Discussion

FIG. 21

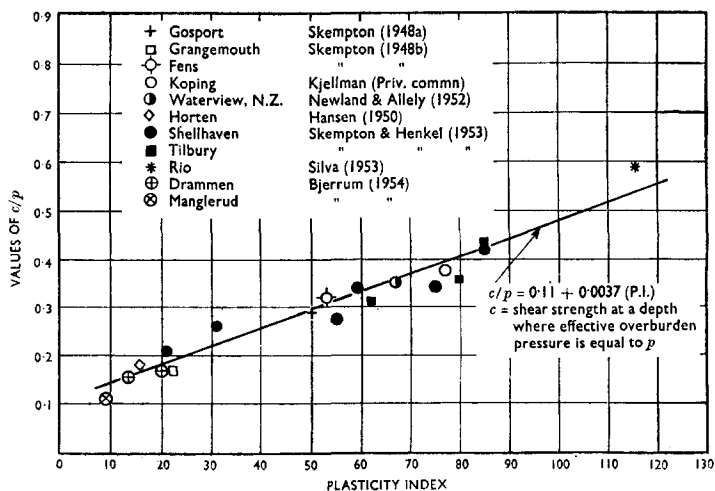
97. Could the Authors give more details concerning the clay, such as the water content, liquid and plastic limits, and the variation of strength with depth? In normally consolidated clays the strength c at any depth was proportional to the effective overburden pressure p , and the ratio c/p had been shown to be correlated with the plasticity index of the clay* (Fig. 21). Therefore a useful method existed for checking the strength obtained

* That correlation, and full references to the sources of information, were given by Skempton in discussion on "The structure of inorganic soil." Proc. Am. Soc. C.E., vol. 80, Separate No. 478 (1954), p. 19. Additional data from Bjerrum (*loc. cit.*) had been included in Fig. 21.

153. Those samples showed no correlation between c/p and plasticity index. Four of the above triaxial test results plotted below Professor Skempton's line (Fig. 21): of those, three (Nos 6, 7 and 8) were grey silty clays which were not really typical, while the fourth (No. 9), a sandy clay, was only very slightly below the line.

155. Those were all above (mostly considerably above) the line in Fig. 21, and showed no consistent relationship between c/p and P.I. It appeared, therefore, that the conditions under which the material in Kowloon Bay had been deposited were different from those to which Fig. 21 related.
